Supplemental Safety Evaluation
For The
General Electric Topical Report
Qualification Of The One-Dimensional
Core Transient Model For
Boiling Water Reactors
NEED-24154 and NEDE-24154P
Volumes I, II and III

Reactor Systems Branch, DSI

Figure 2-1. 5% Significance Coefficient (A) vs. Surveillance Data in Cycle

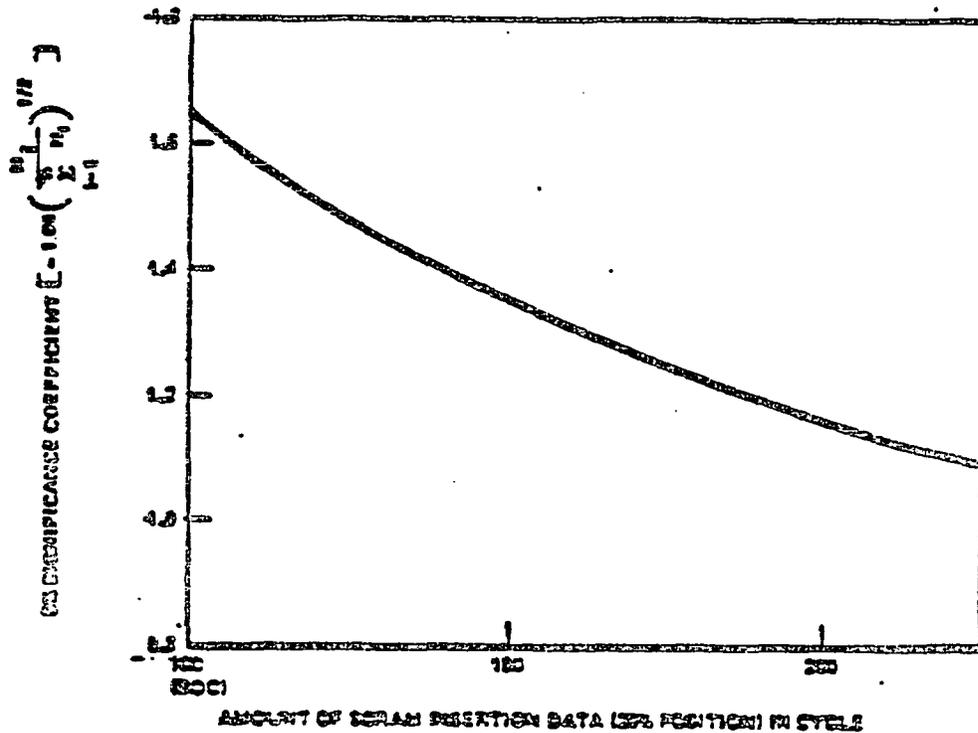
The relationship between the coefficient, A, and the amount of surveillance data generated during the cycle is illustrated in Figure 2-1. As more data become available through the performance of in-cycle surveillance tests, the coefficient decreases, as does the acceptance criterion, τ_2 . Thus, the screen speed criterion is being tightened as the cycle progresses, based on the assumption that, as more screen data become available during the cycle, the uncertainty in the mean value estimation should decrease.

We find the screen insertion time conformance procedure to be acceptable.
